Zlin Aviation S.R.O.

Safety Alert	N°04	06 September 2007
---------------------	-------------	--------------------------

- **Airplanes affected:**
Savage Aiplanes: 120 – 121 – 122 – 124 – 125 – 129
- **Subject:**
Change brake pliers(fig1)
- **Reason:**

Fig1

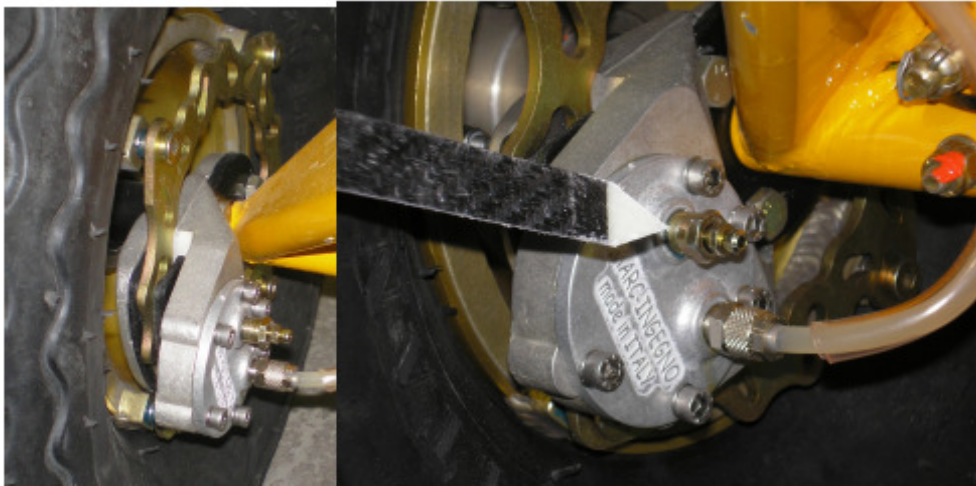
The company Marc-Ingegno has found an anomaly in the pliers he has produced and sold to Zlin Aviation.
- **Compliance:**
Issue date of SA
- **Material required:** New pliers.
- **Accomplishment:**

1. Remove the oil from brake hydraulic system. Use the valve on the pliers to put oil in a bottle(you will use this oil for the new application).(fig2)
2. Remove the rilsan from brake pliers.(fig3)
3. Unscrew the axle's bolt and remove the axle from landing gear. (fig4)
4. Unscrew the disc's bolts and remove the disc.(fig5)
5. Unscrew the wheel and remove it.(fig6)
6. Remove brake pliers from the axle.
7. Remove rilsan attack.
8. Using loctite for oil you screw valve and rilsan attack on the new brake pliers.
9. Drill the new brake pliers using the same distance of old piece.
10. Install new brake pliers on the axle.
11. Install the wheel.
